RAI: Volume 3, Chapter 2.2.1.2.2, Number 1

Provide a transparent technical basis to demonstrate that the event trees and fault trees used to calculate the early failure probabilities of the waste package and drip shield adequately represent all potentially significant failure sequences.

RAI: Volume 3, Chapter 2.2.1.2.2, Number 8

Provide additional justification for the calculated probability of drip shield emplacement failure.

Figure 1. Alternate Event Tree for Evaluating Improper Emplacement of the Drip Shield

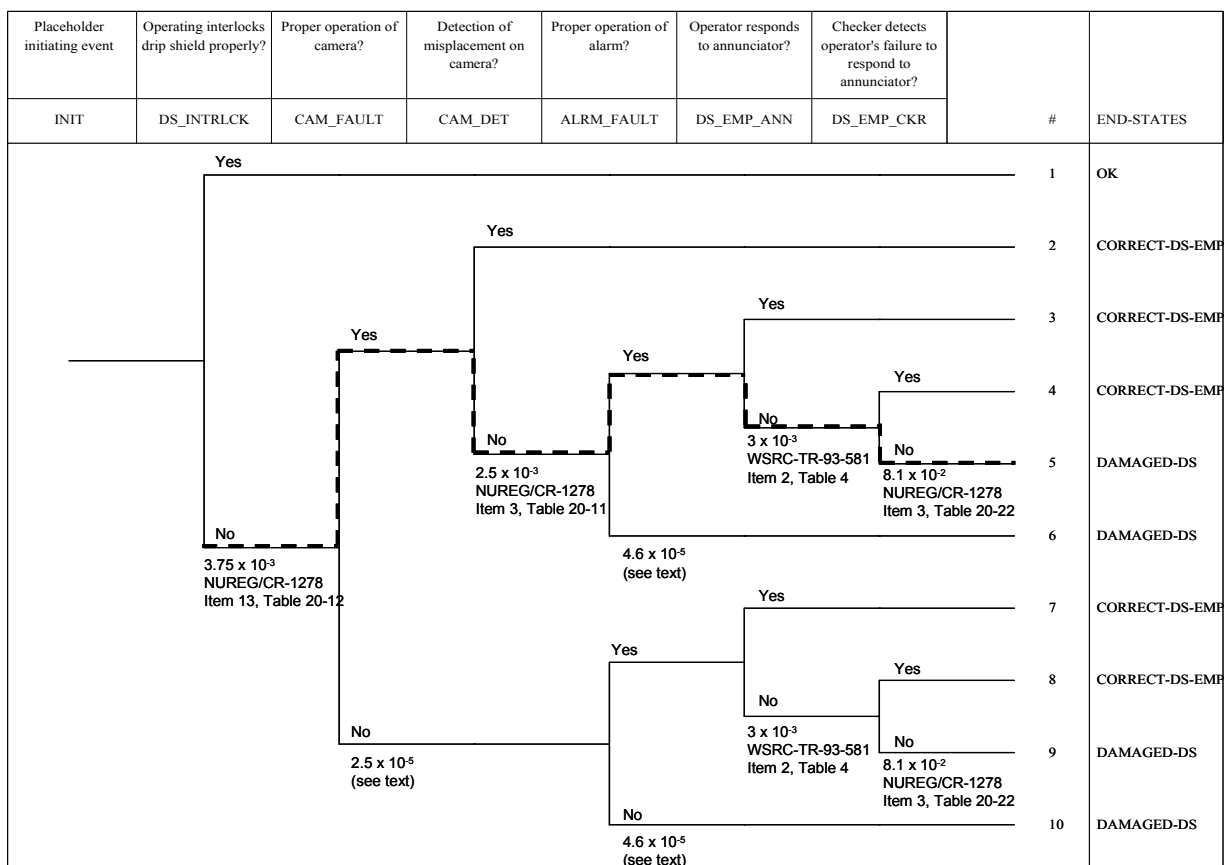
Basis: The only emplacement error that DOE identified for the drip shield is improper interlocking between adjacent plates such that there is a gap (SNL 2007a, as referenced in SAR, Section 2.3.6.8.4.3.2.4). DOE intends to use a camera to remotely monitor the emplacement of drip shields. Concerns about how this action will be reliably estimated are contained in RAI 5. Additionally, each event in the DOE event sequence that leads to improper drip shield emplacement is a human error event. DOE apparently assumes that no equipment or mechanical errors will occur during drip shield emplacement. This assumption should be supported by a technical basis that demonstrates mechanical or equipment reliability is not a significant component of the drip shield emplacement failure analysis.

Proper interlocking of adjacent drip shields will be monitored remotely by high-resolution cameras (SAR Section 1.3.4.7.2). In addition to the camera, drip shield alignment is also monitored by means of an alarm system that will be developed to detect misalignment and alert the operator (SAR Table 1.3.4-5, Parameter Number 07-14). Thus, equipment failure would allow misalignment of a drip shield to remain undetected only if both the camera and the alarm system malfunctioned, and both the operator and the checker failed to detect malfunction of the equipment. Figure 1 illustrates an event tree estimating the probability of failure to achieve proper interlocking of adjacent drip shields which adds events describing equipment reliability to the fault tree presented in Figure B-22 of *Analysis of Mechanisms for Early Waste Package/Drip Shield Failure* (SNL 2007). Figure B-22 of that report (SNL 2007) considered only events related to human error as potentially leading to improper emplacement of the drip shield. For ease of comparison of Figure 1 with Figure B-22, the event sequence leading to the damaged drip shield end state that is common to both figures is highlighted.

Evaluation of the event tree shown in Figure 1 yields a mean probability of improper emplacement of the drip shield of 2.7×10^{-9} per drip shield, an increase over the probability of 2.19×10^{-9} (Table 1 in DOE's response to RAI 3.2.2.1.2.2-002) that results from the event tree presented in Figure B-22 of *Analysis of Mechanisms for Early Waste Package/Drip Shield Failure* (SNL 2007). Improper drip shield emplacement is one of four possible event sequences that contribute to the overall probability of drip shield early failure. Table 1 in DOE's response to RAI 3.2.2.1.2.2-002 provides values for all four event sequences. If the increase in the probability of improper drip shield emplacement due to the possibility for equipment failure were included, the sum of the mean probabilities over all event sequences would not change from 2.22×10^{-6} . Thus, inclusion of the possibility of equipment failure has a negligible effect on the analysis of early failures reported in *Analysis of Mechanisms for Early Waste Package/Drip Shield Failure* (SNL 2007).
